Access Compliance Report

Public Rights-of-Way

(Curb Ramps)

Intersection ID: 16897	Main Street: MONTAGUE_ST	Cross Street: SUMMEY_AV	Location: S
ADA ID: BFC2C5601F17	Ramp Type: ParaDiag	Initial Pass/Fail: Fail	Overall Compliance: No
			Severity Score: 21.25

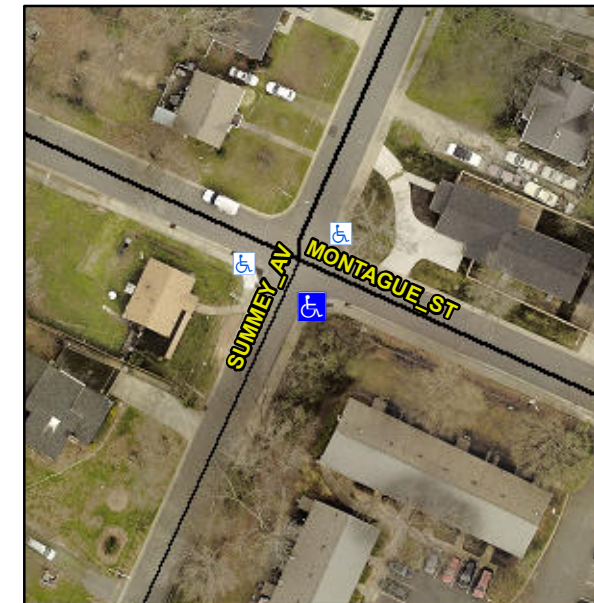
RT RP < 5%,

R304.5.1, R304.3.2

Remove & Replace Curb Ramp With Two New Directional Ramps or Equivalent.
